Memorandum

TO: Columbia River Crossing Task Force
FROM: CRC Pedestrian and Bicycle Advisory Committee (PBAC)
SUBJECT: PBAC Recommendations for World Class Pedestrian and Bicycle Facilities

Columbia River CROSSING

PBAC Proposed Pedestrian and Bicycle System for Replacement Bridge

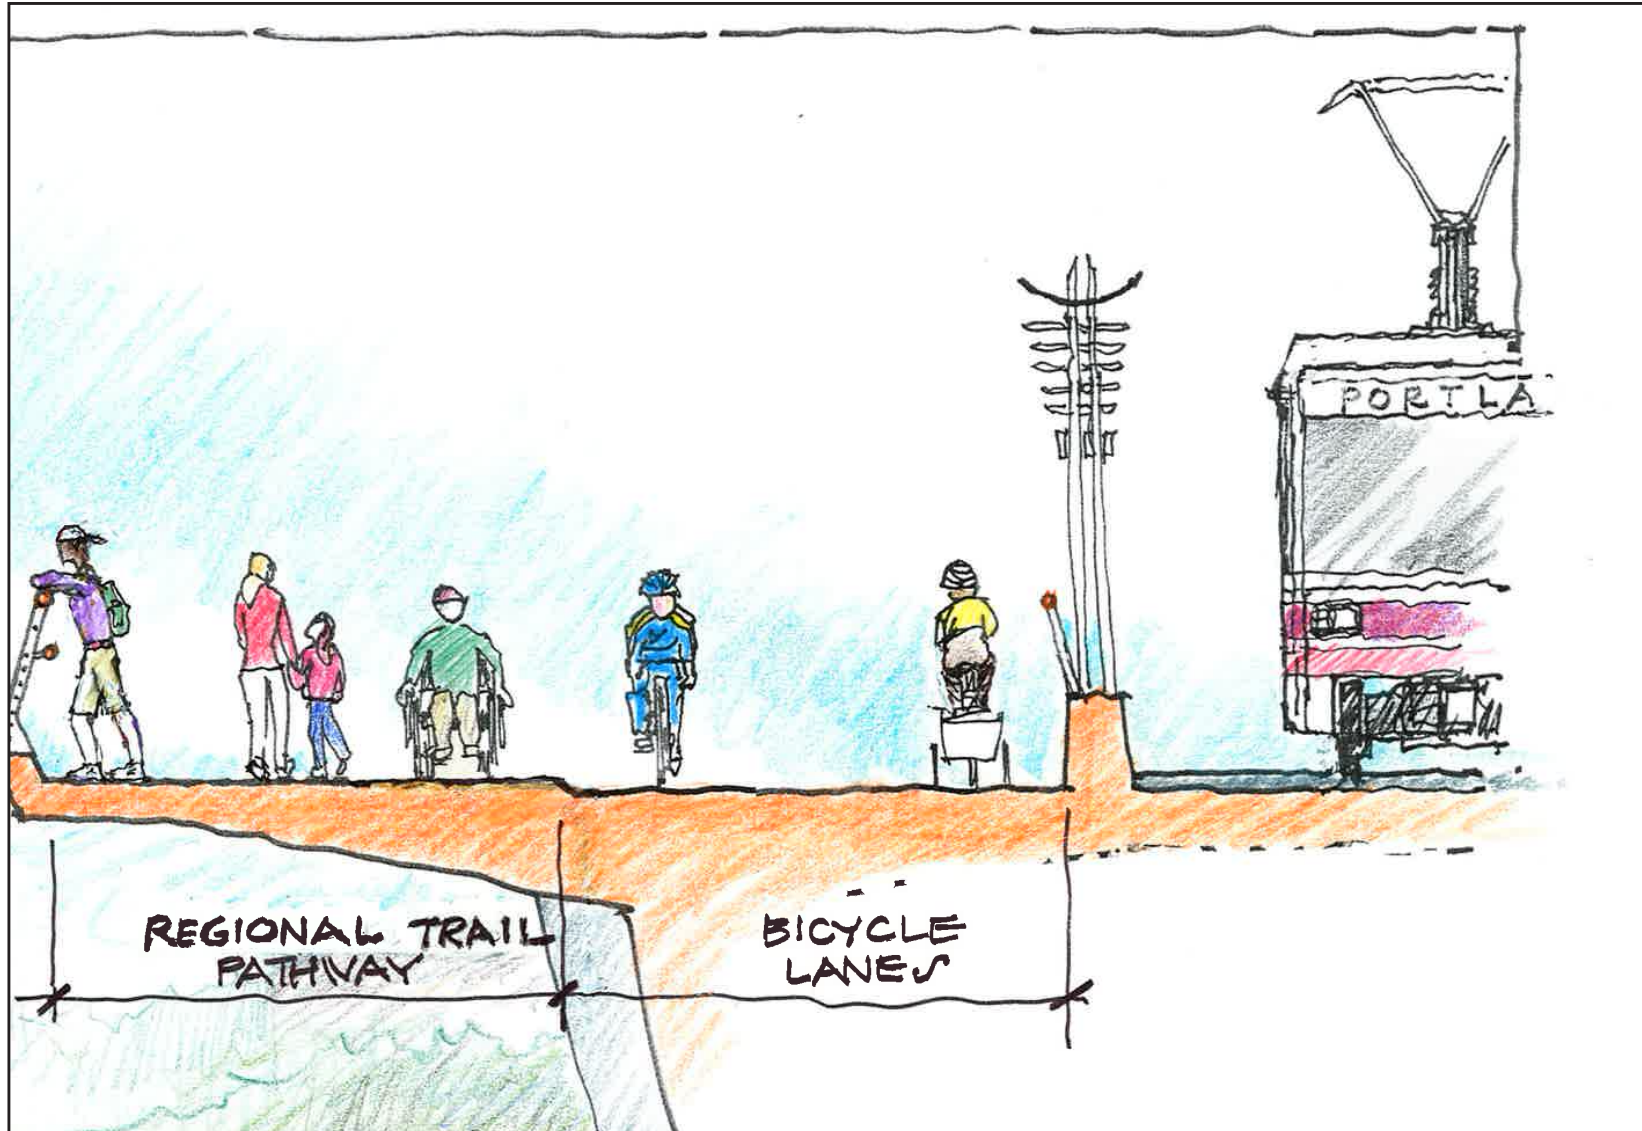
- The overall pathway on the western bridge (adjacent to the transit guideway) must provide separation between recreational users and higher speed bicycle users. To provide this separation, a 12-foot wide regional trail should be provided adjacent to, and to the west of, a pair of six-foot wide bicycle lanes (see attached rendering). These recommended widths are exclusive of potentially needed shy distances, i.e., free and clear of poles and other obstructions to enable safe pedestrian and bicycle movement (a summary of agency standards for multiuse paths, sidewalks and bike lanes is attached).

The regional trail would accommodate pedestrians, persons with disabilities, seniors, families with children, tourists, roller-skaters, and recreational bicycle riders. The adjacent bicycle lanes would be used by bicycle commuters and other faster-moving bicyclists. The regional trail would be at a slightly higher level than the bicycle lanes, but bicyclists in the bicycle lanes would be able to access the trail. Different paving treatments and/or patterns should differentiate the regional trail and the bicycle lanes.

- In addition to the combined regional trail and bicycle lanes on the western bridge, an eight-foot wide sidewalk should be provided on the eastern bridge (the bridge that would serve the northbound traffic lanes) across both the Columbia River and the North Portland Harbor. The sidewalk across the North Portland Harbor would touch down on Hayden Island and use surface street sidewalks to connect to the sidewalk across the Columbia River.
